Agenda
Village of Arlington Heights
Design Commission
Community Room, 3rd Floor

Arlington Heights Village Hall
33 S. Arlington Heights Road
Arlington Heights, IL 60005
June 14, 2016
6:30 PM

- A. DC#16-054 - 2 N. Phelps Ave. - SF/Teardown
- B. DC#16-039 - 503 N. Gibbons Ave. - SF/New
- C. DC#16-065 - 415 N. Gibbons Ave. - SF/New
- D. DC#16-056 - Lexington Towne Subdivision - 909 & 929 W. Campbell St. - SF/New
- E. DC#16-063 - Ivy Hotel - 519 W. Algonquin Rd. - Commercial

FRONT ELEVATION

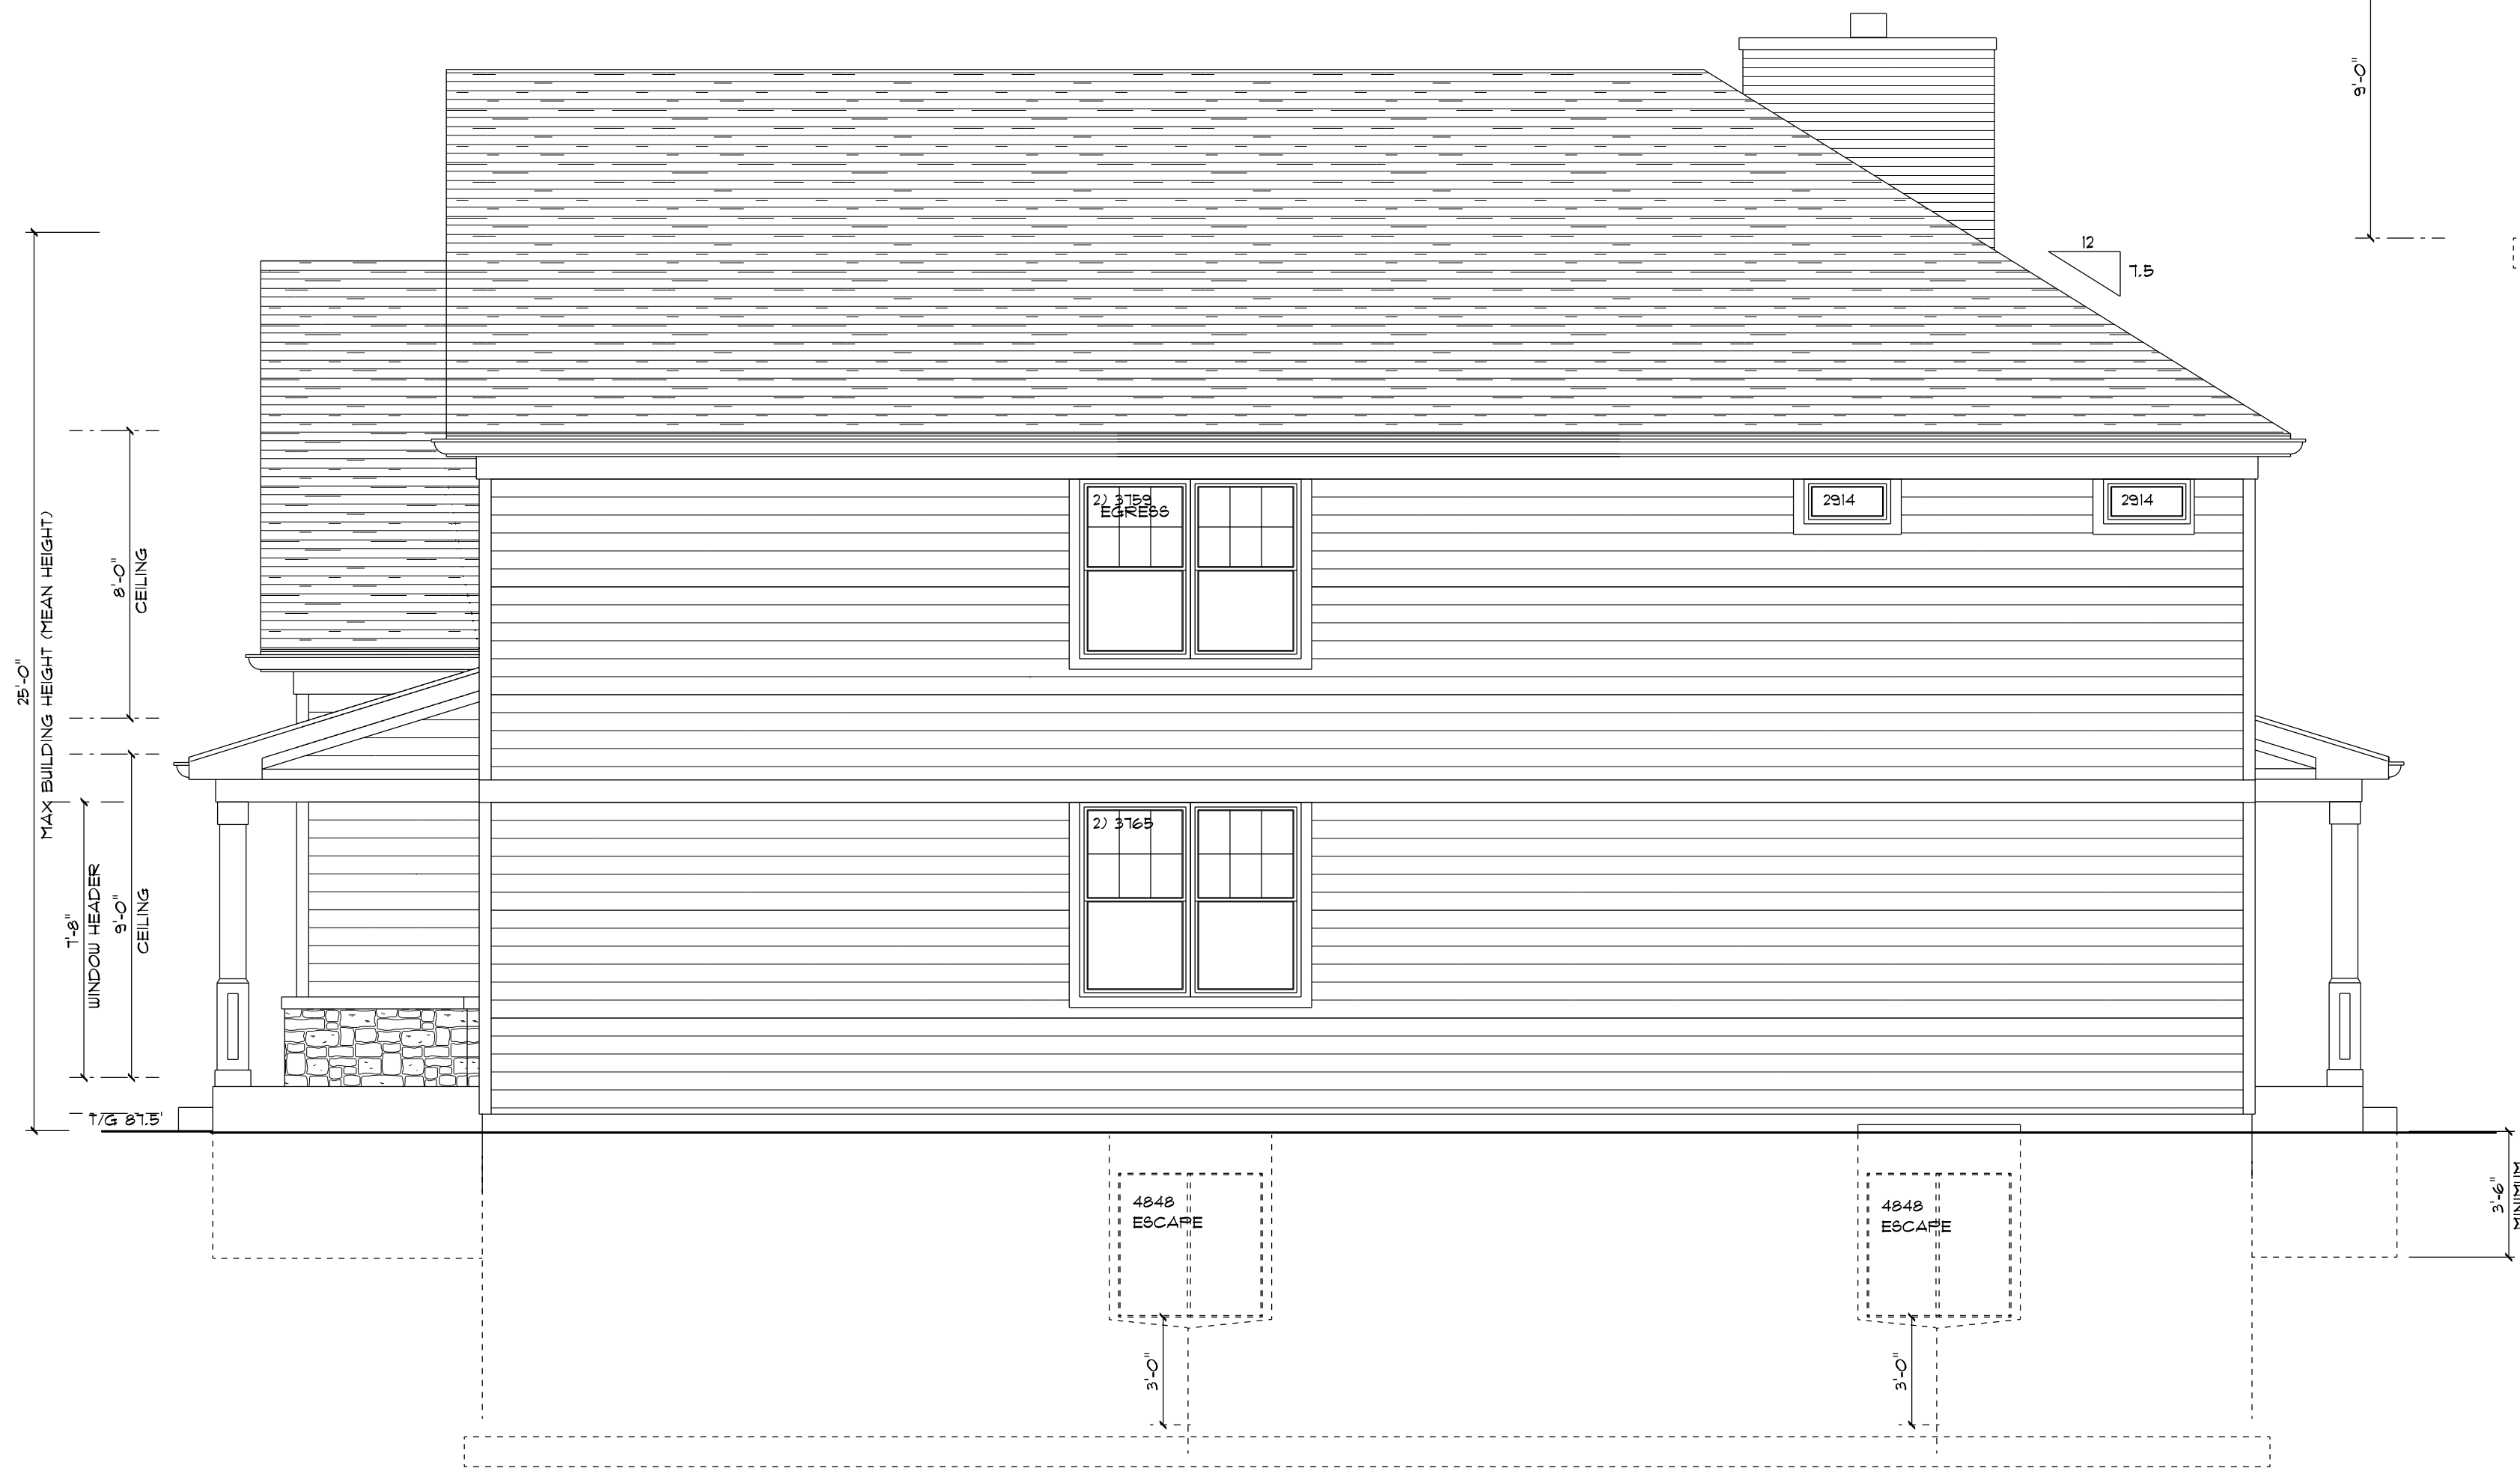
3. A window is recommended to be added on the side of the first floor office to help break up the large side wall.
4. Change the large gable above the second floor windows to a smaller gable/dormer.

1. Return the stone base on the front of the garage down the full length of the side of the garage.
2. A window is recommended to be added on the side of the first floor office to help break up the large side wall.
3. Change the large gable above the second floor windows to a smaller gable/dormer to visually reduce the scale of the home.
4. It is recommended to preserve the existing mature tree in the front yard to soften the scale of the house.

It is recommended that the Design Commission **evaluate** the design for the proposed new single-family residence to be located at 2 N. Phelps Avenue. This recommendation is subject to compliance with the architectural plans received 5/9/16, and the following:

1. Consider a different design with a detached garage and one-and-a-half-story massing.
2. Return the stone base on the front of the garage down the full length of the side of the garage.

3. A window is recommended to be added on the side of the first floor office to help break up the large side wall.
4. Change the large gable above the second floor windows to a smaller gable/dormer.
